AREA TOPOGRAPHICAL SURVEY		
PROPOSED CONVOCATION CENTER ARKANSAS STATE UNIVERSITY ONESBORO, ARK.		
PREPARED BY: HAYWOOD KENWARD & ASSOCIATES, INC. CIVIL Engineering & Surveying Jonesboro, Ark.	DATE: 10-83	SCALE: 1"=100'
DRAWN BY: J.K.		1:1

A.S.U. CONVOCATION CENTER

SITE PLAN

7/25/84

FLOOR PLAN QUADRANT "B" FIRST LEVEL

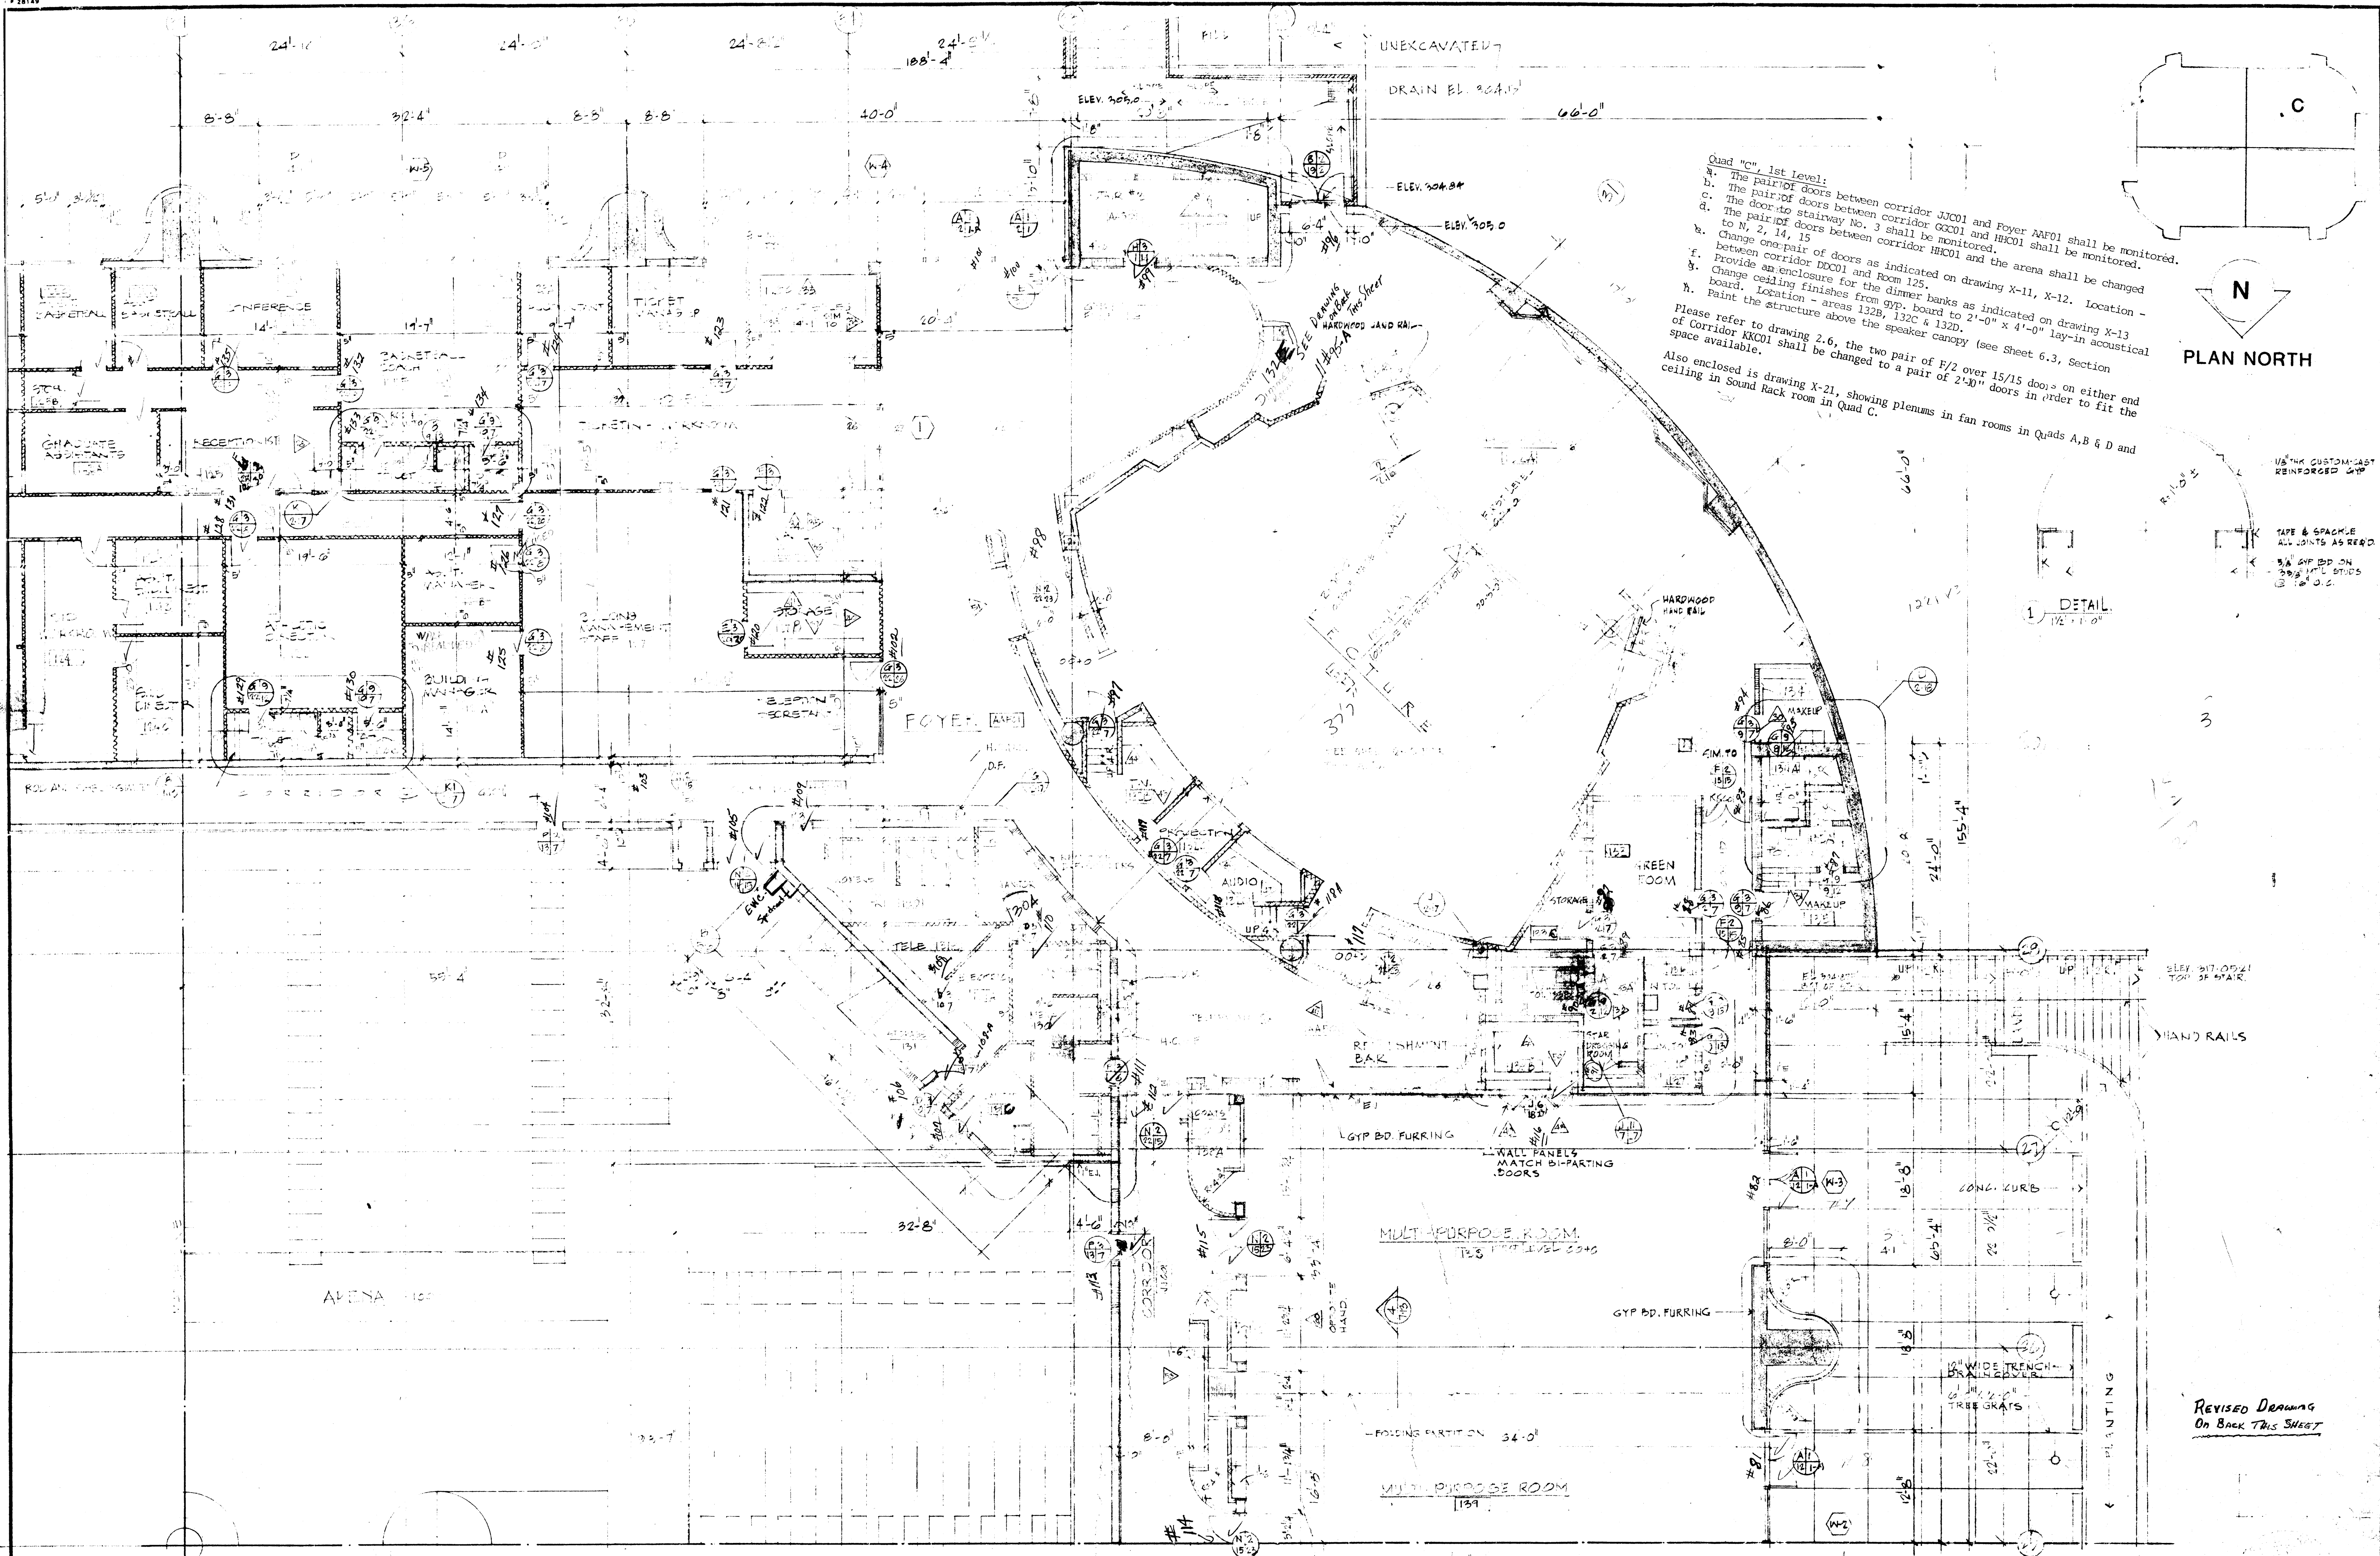
- Quad "C", 1st Level:
- a. The pair of doors between corridor JKC01 and Foyer AF01 shall be monitored.
 - b. The pair of doors between corridor GKC01 and HKC01 shall be monitored.

- c. The door to stairway No. 3 shall be monitored.
 - d. The pair of doors between corridor HKC01 and the arena shall be changed to N, 2, 14, 15.
 - e. Change one pair of doors as indicated on drawing X-11, X-12. Location - between corridor DDC01 and Room 125.

- f. Provide an enclosure for the dinner banks as indicated on drawing X-13 of Corridor KKC01 shall be changed to a pair of 2'-0" x 4'-0" lay-in acoustical space available.

- g. Change ceiling finishes from gyp. board to 2'-0" x 4'-0" lay-in acoustical board. Location - areas 132B, 132C & 132D.
 - h. Paint the structure above the speaker canopy (see Sheet 6.3, Section

- Please refer to drawing 2.6, the two pair of F/2 over 15/15 doors on either end of Corridor KKC01 shall be changed to a pair of 2'-0" doors in order to fit the space available.

FLOOR PLAN QUADRANT 'D' FIRST LEVEL

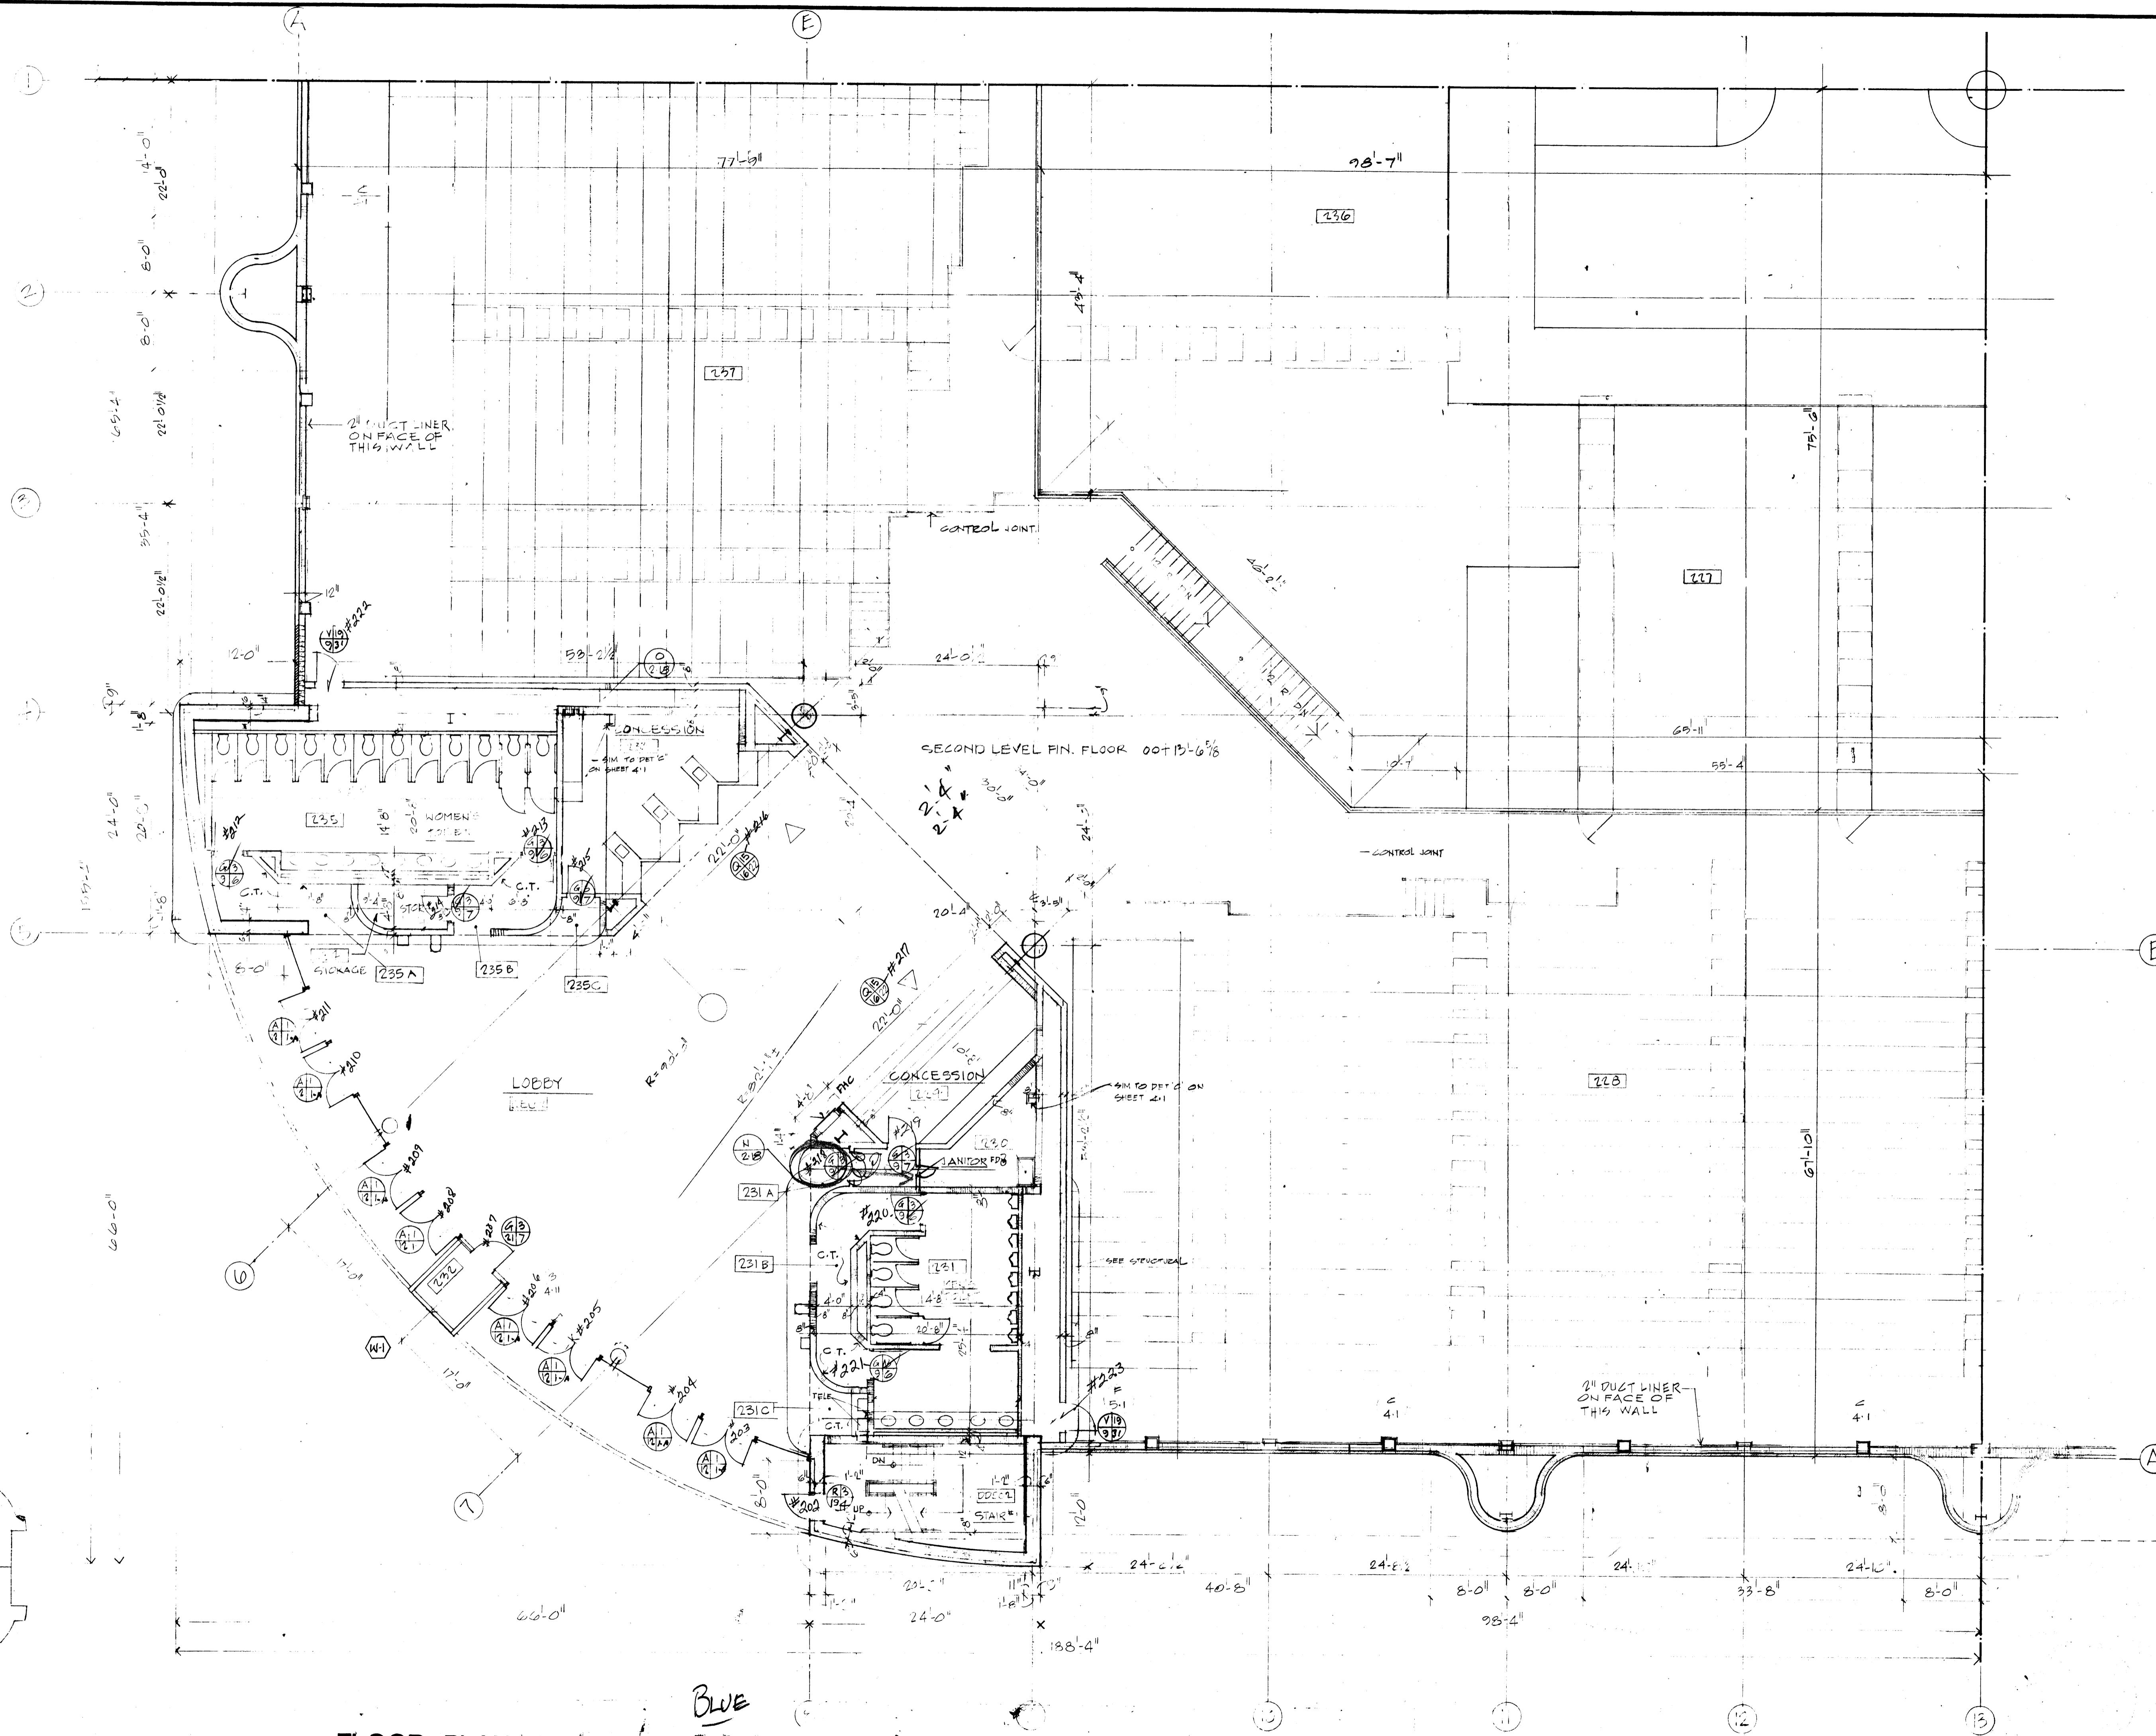
- Quad 'D', 1st Level:
- a. Omit one pair of doors. Location - between corridors VWC01 and 101K.
 - b. Omit one pair of doors. Location - between corridors G301 and 101K.
 - c. Change one pair of doors as indicated on drawing X-11 and X-12. Location - between corridor BRL01 and room 105.
 - d. Provide a door closure on one door. Location - between 101B and 101C.
